RETRAN-02
Modeling and Qualification
For Westinghouse
Pressurized Water Reactors
Non-LOCA Safety Analyses

Supplement 1-Thick Metal Mass
Heat Transfer Model and
NOTRUMP-Based Steam Generator
Mass Calculation Method

SAFETY EVALUATION BY THE OFFICE OF NUCLEAR REACTOR REGULATION

NRC Requests for Additional Information (RAIs) with Westinghouse Responses

Figure 14-1 Comparison of the LOFTRAN Thick Metal Model to the Schneider Predicted Results

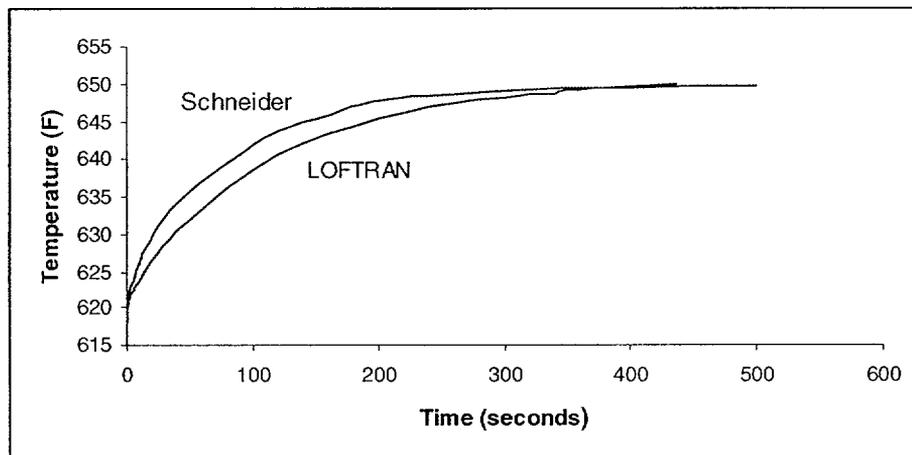
14. WCAP-14882-S1-P, Revision 0 provides the technical basis for the proposed RETRAN thick-metal mass heat transfer model. This topical report does not provide any information regarding verification or validation of the proposed RETRAN thick-metal mass heat transfer model. Please provide a discussion of the work performed to verify that the model performs as expected and that the amount of energy transferred to and absorbed by the RCS metal is accurate and realistic. Include results of any

comparisons made to test data or other benchmarking, and demonstrate that the RETRAN thick-metal mass heat transfer model is not overestimating heat transfer to the RCS metal.

As discussed in the response to RAI #5, Westinghouse performed extensive comparisons of the LOFTRAN thick metal model to the expected response. A comparison of the LOFTRAN thick metal model results for the steam generator inlet metal section to what would be expected based on the data obtained from *Temperature Response Charts*, Dr. P.J. Schneider, 1963 John Wiley & Sons, Inc. was performed for an increase in temperature from 618°F to 650°F. As can be seen in Figure 14-1, the LOFTRAN thick metal model response to an increase in the fluid temperature results in a very similar increase in the metal mass temperature, with the LOFTRAN results being slightly conservative. This conservative response, in addition to the fact that a large portion of the RCS thick metal masses are completely ignored, ensures that the thick metal model is conservatism for use in heatup transients.
